# ARBORICULTURAL OPINION

## PROPOSED SUBDIVISION of 31 BELLARA AVENUE NORTH NARRABEEN

**12 May 2019**

### **TREE PLAN**

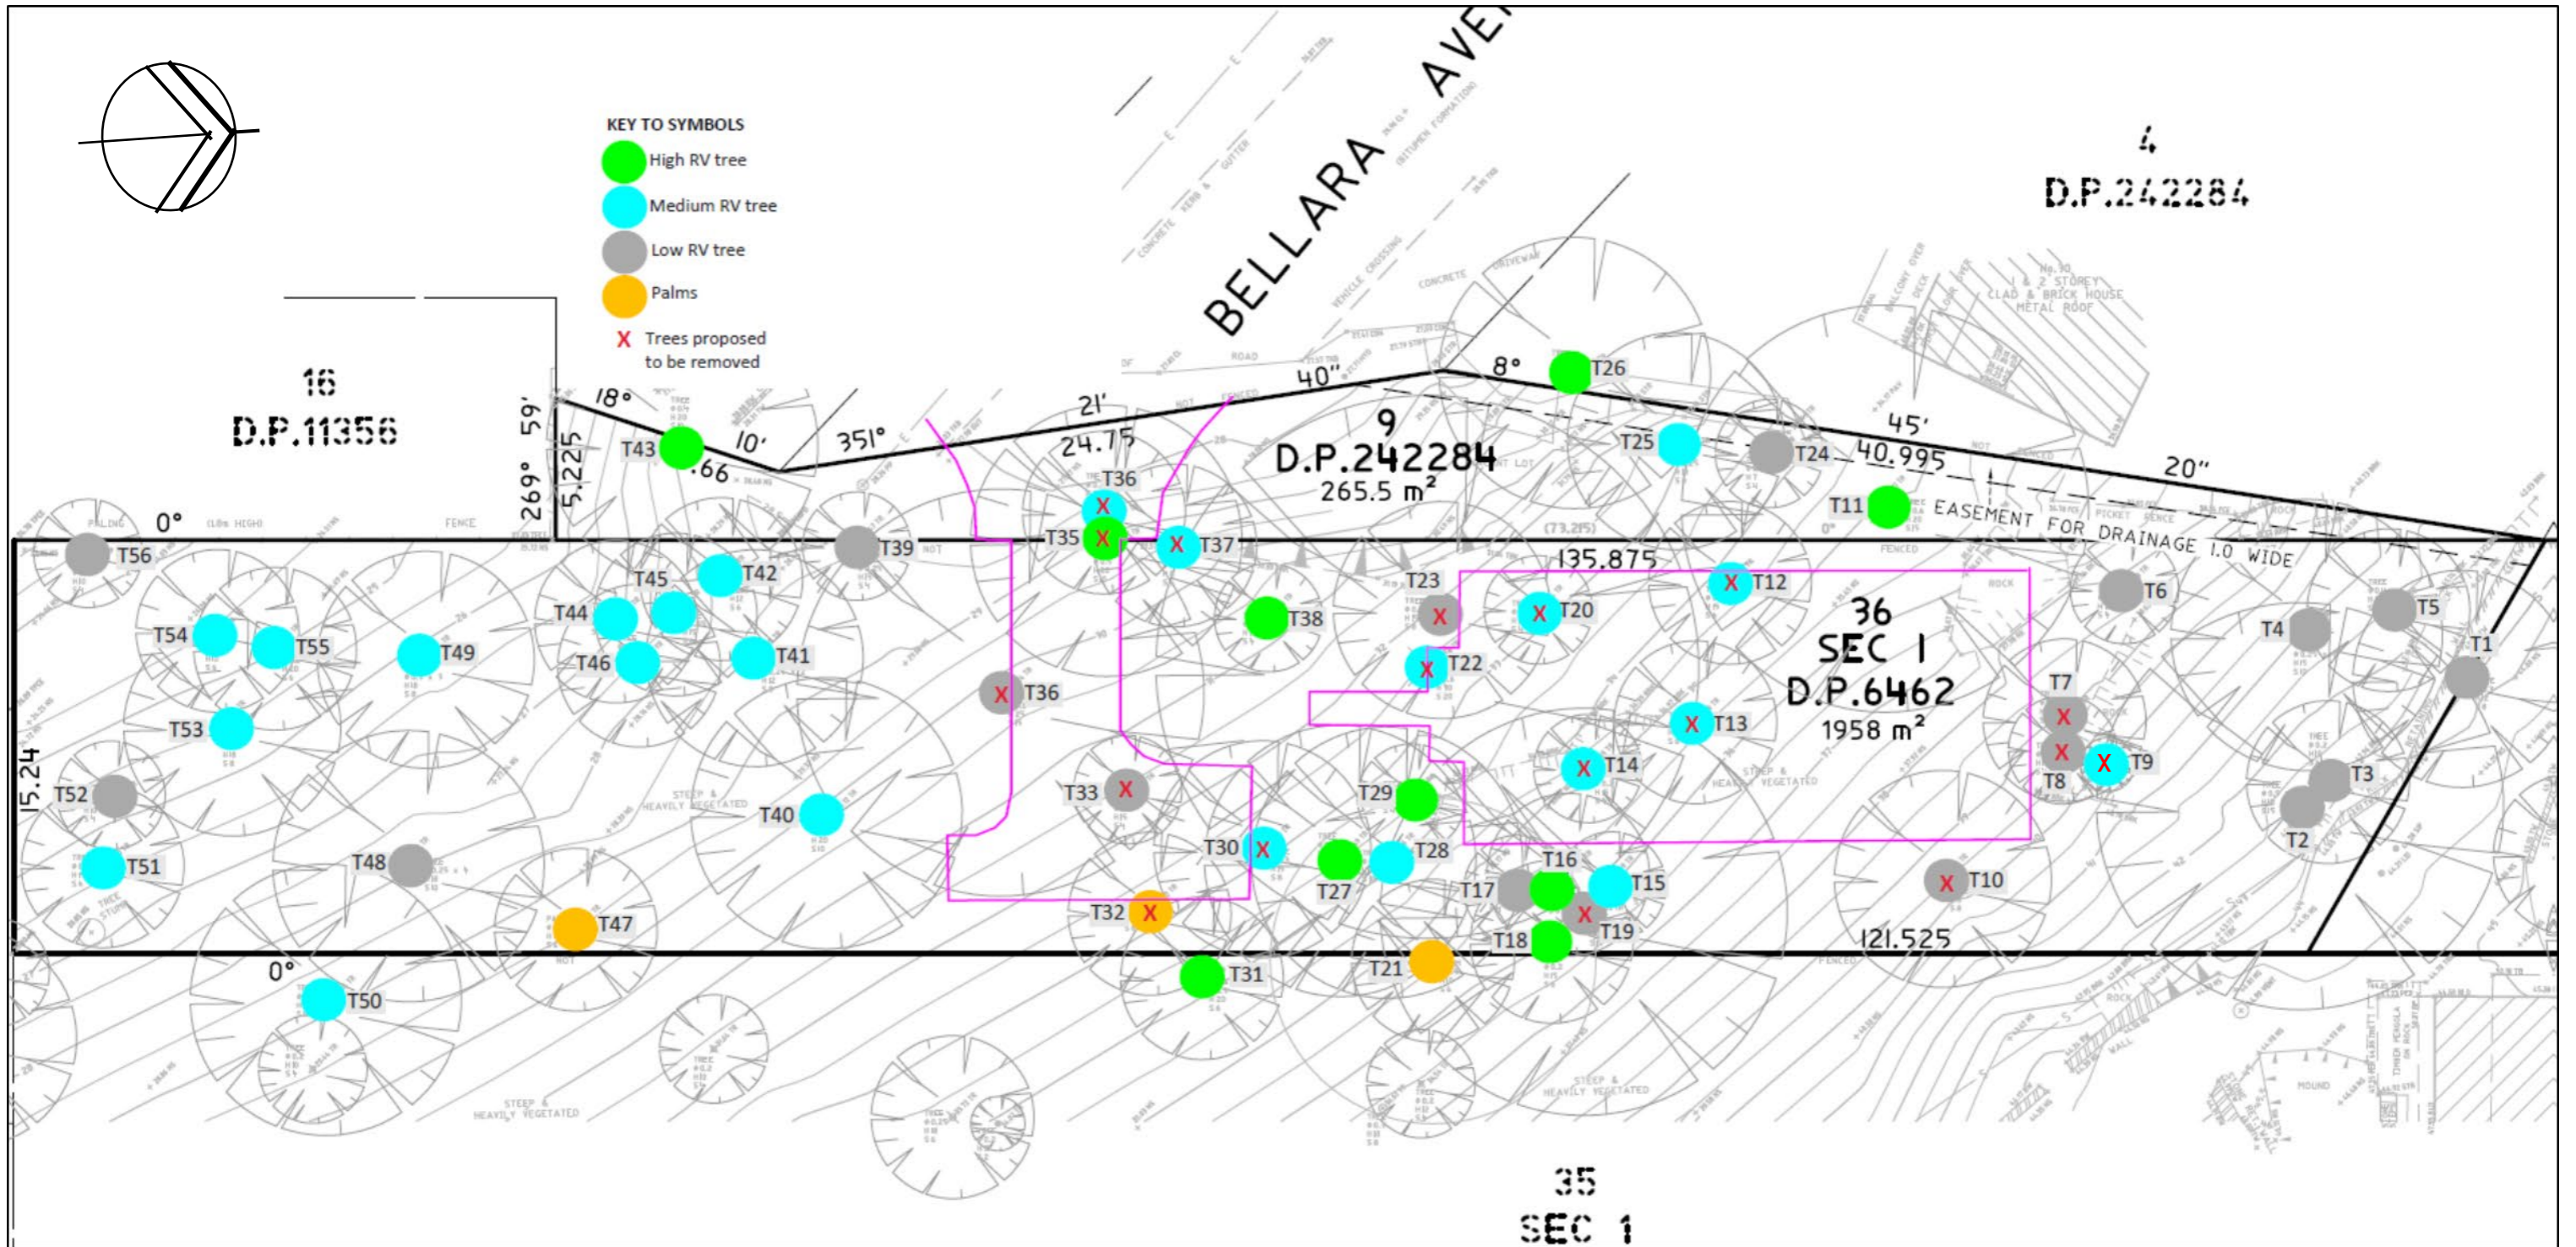
**TREE PLAN** showing tree Retention Values (as amended by Catriona Mackenzie following site visits and tree assessments), and those trees proposed to be removed. The indicative driveway and building footprints are shown as pink outlines on the above plan.

Source: Excerpt of Survey Plan prepared by CMS Surveyors, dated 23 August 2013, marked up by C. Mackenzie. May 2019. Not to scale.
